# Site Accessibility Evaluation

## Shueyville Shed

3341 120th St NE  
Solon, IA 52333

ADA Only

### Finding: 3

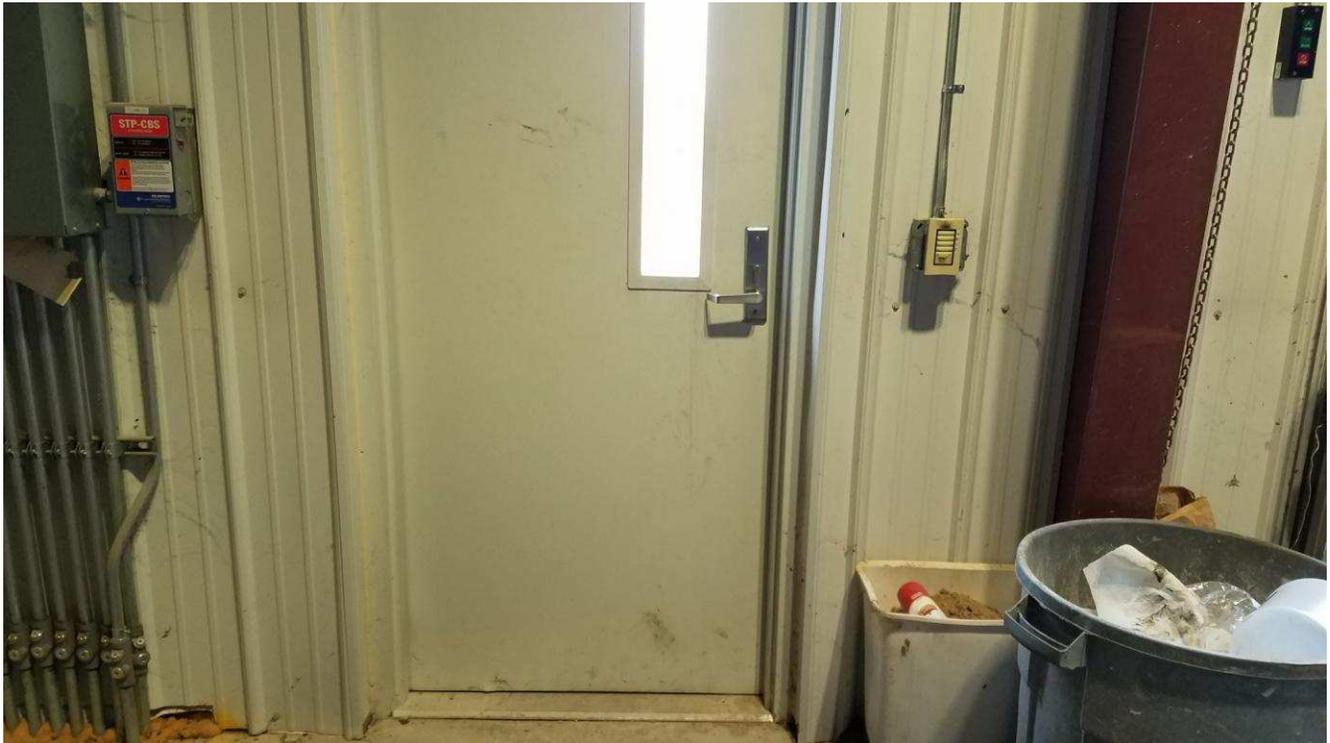
The door is equipped with a door closer and returns to a closed position too quickly.

Door closers and gate closers shall be adjusted so that from an open position of 90 degrees, the time required to move the door to a position of 12 degrees from the latch is 5 seconds minimum.

entry- closes fast

Inspect, adjust, and maintain closing speed on door closers

### Finding: 4

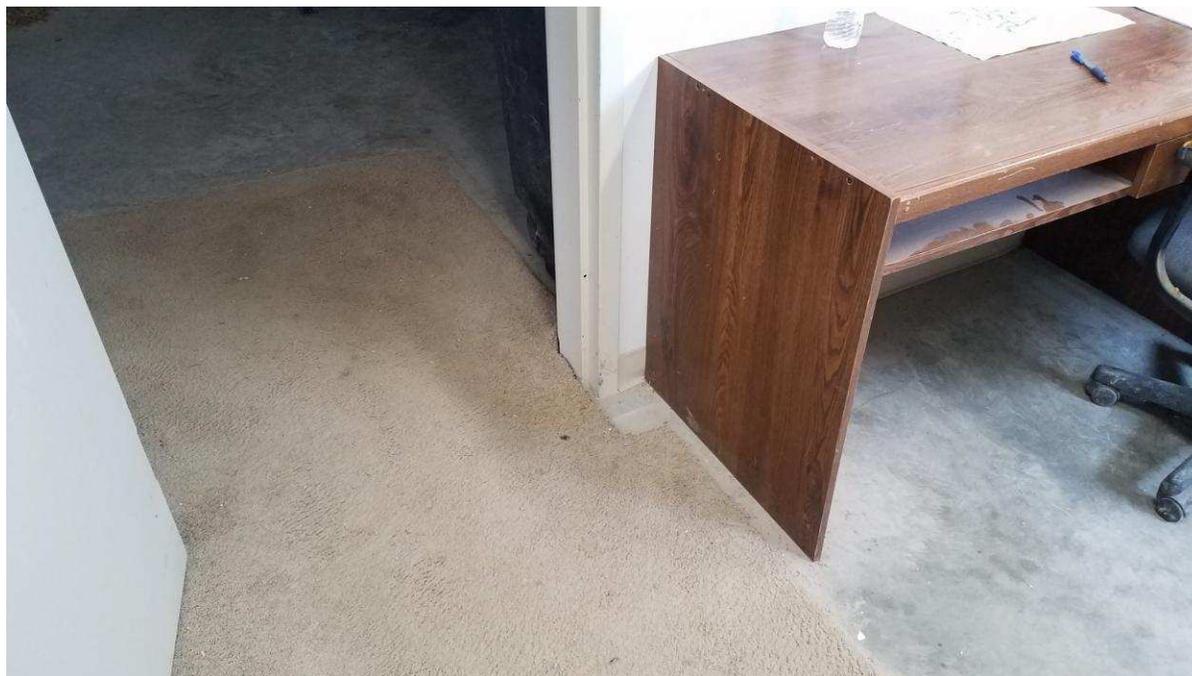
The maneuvering space on the pull side of the door does not adequately extend beyond the latch side of the door.

Maneuvering space for interior doors on the pull side with a front approach must be flat (2% max. slope in any direction) for a minimum distance of 60 inches in the direction of travel. The width of the maneuvering space must be as wide as the door plus an additional 18 inches on the latch side. This latch side clearance must also be flat (2% max. slope in any direction) and clear of obstructions.

office- desk pull side

For all doors along the public circulation route, relocate storage, furniture, and other obstacles to create 60" maneuvering space around doors

### Finding: 7

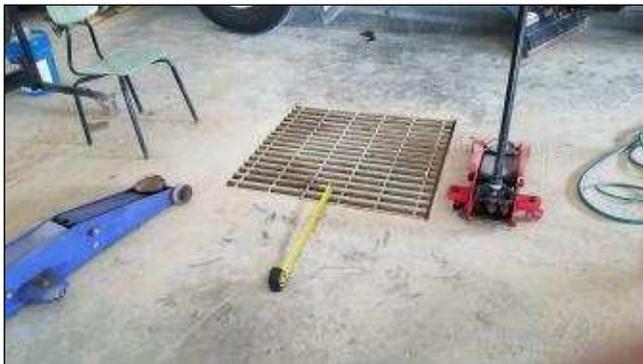
Gratings are spaced greater than a 1/2 inches in the direction of traffic flow.

Openings in floor or ground surfaces shall not allow passage of a sphere more than 1/2 inch diameter. Elongated openings shall be placed so that the long dimension is perpendicular to the dominant direction of travel.

shop- 1.5" grates

Leave as is, grating, integral to the use of the site.

### Finding: 10

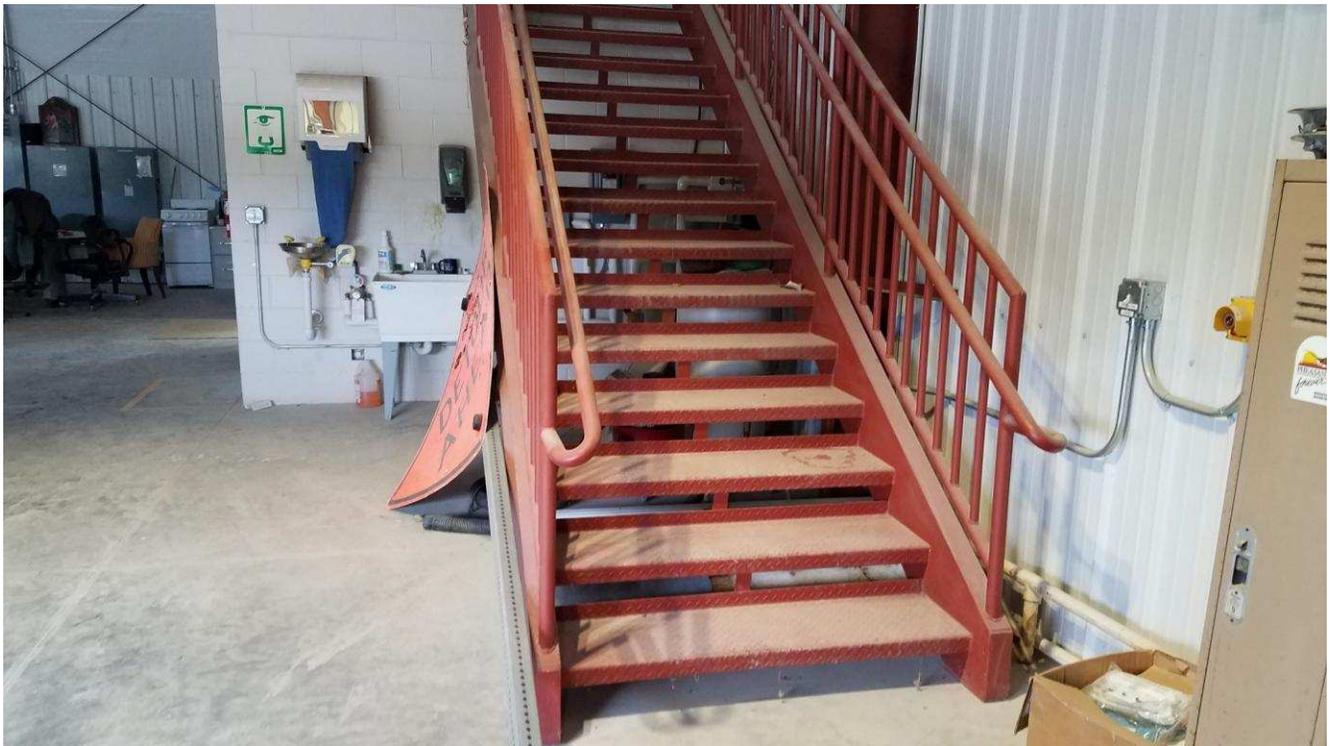
There is a change in level greater than 1/4 inch.

1/4 inch is the maximum vertical rise. Changes in level between 1/4 inch and 1/2 inch must be beveled at 1:2 or less. Changes in level greater than 1/2 inch must be by way of a ramp.

stairs to  
loft/mezzanine

Stairs only to upper level storage, leave as is, employee area only; reassign duties if an employee with a disability requires access here

### Finding: 20

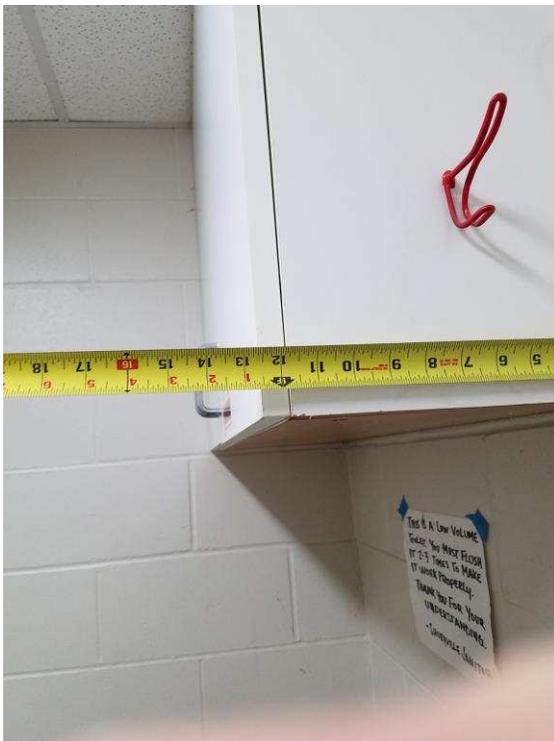
The cabinet projects more than 4 inches into the circulation path.

Wall-mounted objects that have leading edges between 27 inches and 80 inches from the floor must not project more than 4 inches into the circulation path. Protruding objects that extend to the floor or within 27 inches of the floor are cane detectable and are therefore not hazardous. Where it is necessary or desirable to have objects protrude from the wall, a manner of cane detection must be provided.

cabinet protrudes over  
toilet 12.5"

Relocate protruding objects or place cane detectable warning or bollard at foot of item
